ATR on Quality Control Check Report. (Bungalows)

Quality Control Check Report. Stage: After Column Casting (villas)

| QUALITY CONTROL GROUND FLOOR SLAB CHECK PLAN | | N | | Silver Oak Realty | | 23.10.2017 | | Nagalaxmi | |

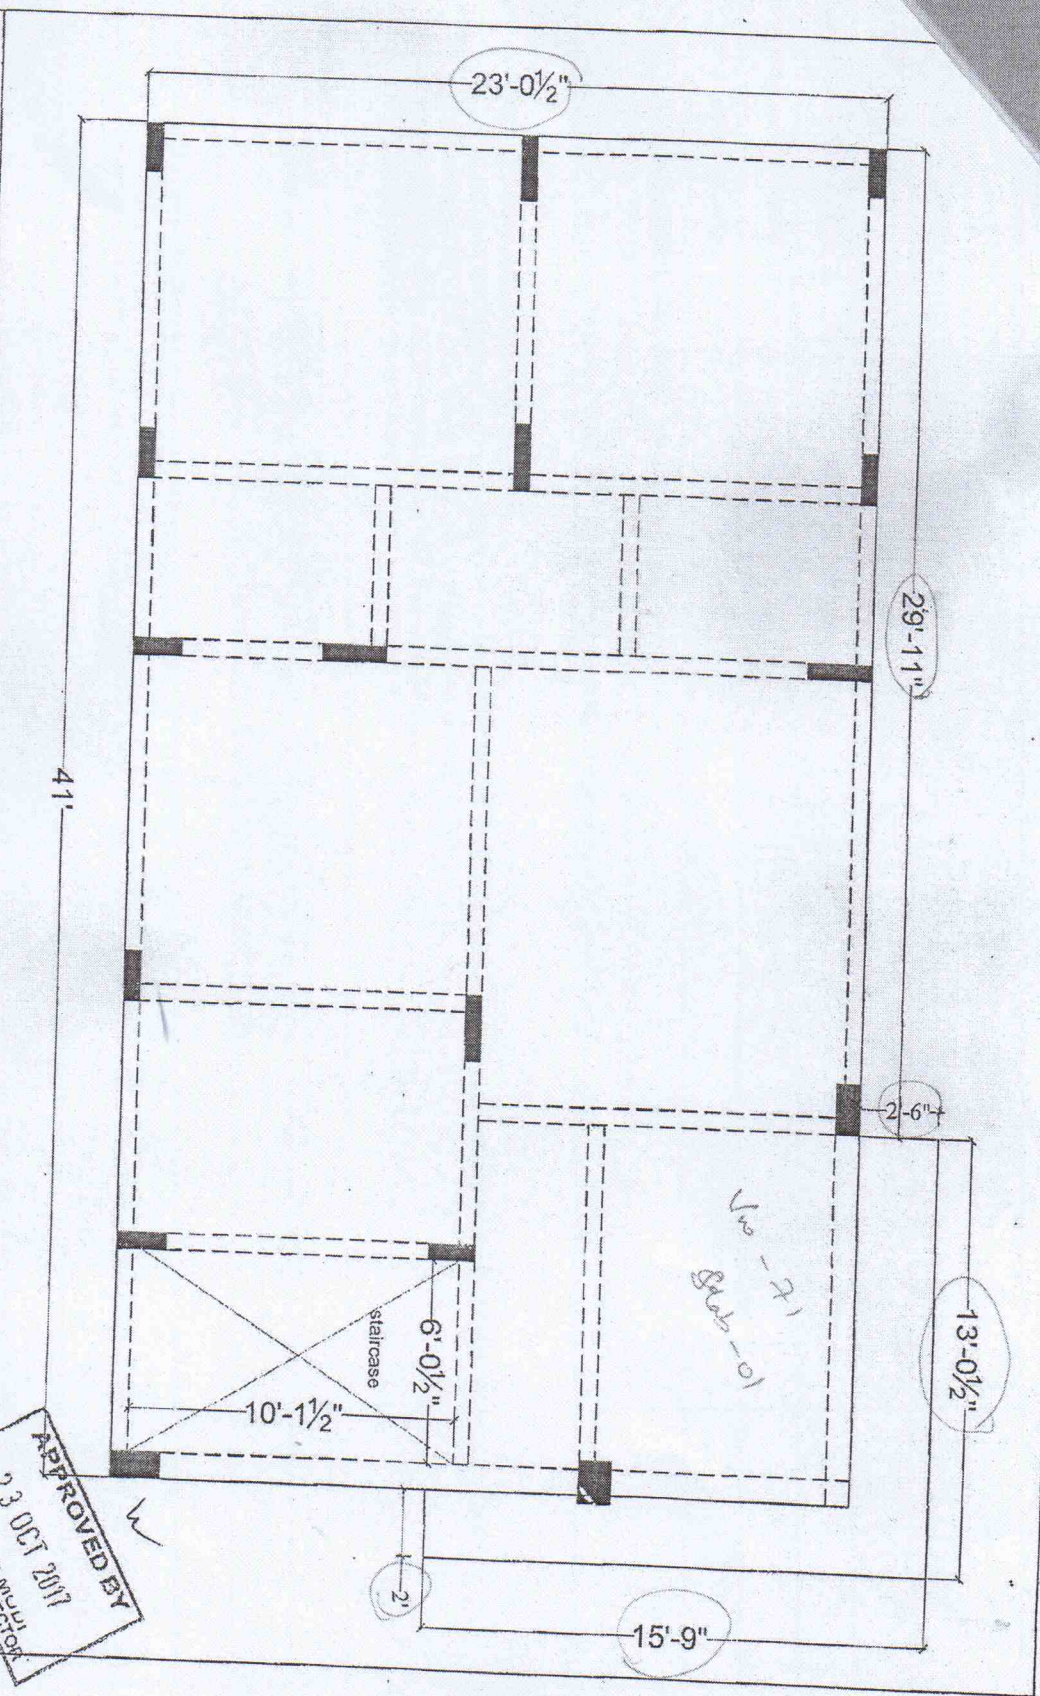
Remarks: A4 works Completed
 ① Column height corrected.
